ADDENDUM A
Staff Report: Z-SP-6-21-7
March 3, 2022

<u>Laveen Village Planning Committee</u>	February 14, 2022
Meeting Date	
<u>Planning Commission</u>	March 3, 2022
Hearing Date	
Request From:	<u>S-1</u> (Approved <u>C-2</u>) (Ranch or Farm Residence District, Approved Intermediate Commercial District) (3.29 acres)
Request To:	<u>C-2 SP</u> (Intermediate Commercial District, Special Permit) (3.29 acres)
Proposed Use	Self-service storage warehouse and underlying commercial uses
Location	Southeast corner of the Loop 202 Freeway and Southern Avenue
Owner	REXCO S202, LLC
Applicant/Representative	Alan Beaudoin, Norris Design
Staff Recommendation	Approval, subject to stipulations

202 and Southern Storage

Preliminary Elevations

BLDG. C NORTH ELEVATION

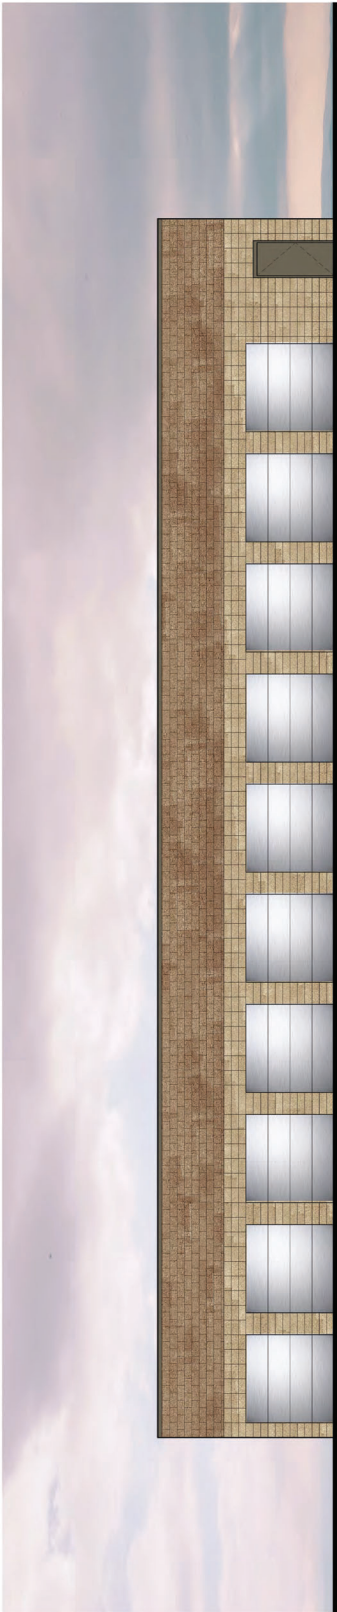
- b. C. ~~All building elevations shall contain architectural embellishments and detailing such as textural changes, pilasters, offsets, recesses, variation in window size and location, and/or overhang canopies.~~ **THE NORTH AND EAST ELEVATIONS OF BUILDING C SHALL INCORPORATE DECORATIVE ELEMENTS SUCH AS PITCHED ROOFS CONSISTENT WITH THE ELEVATIONS OF BUILDINGS A AND B.**
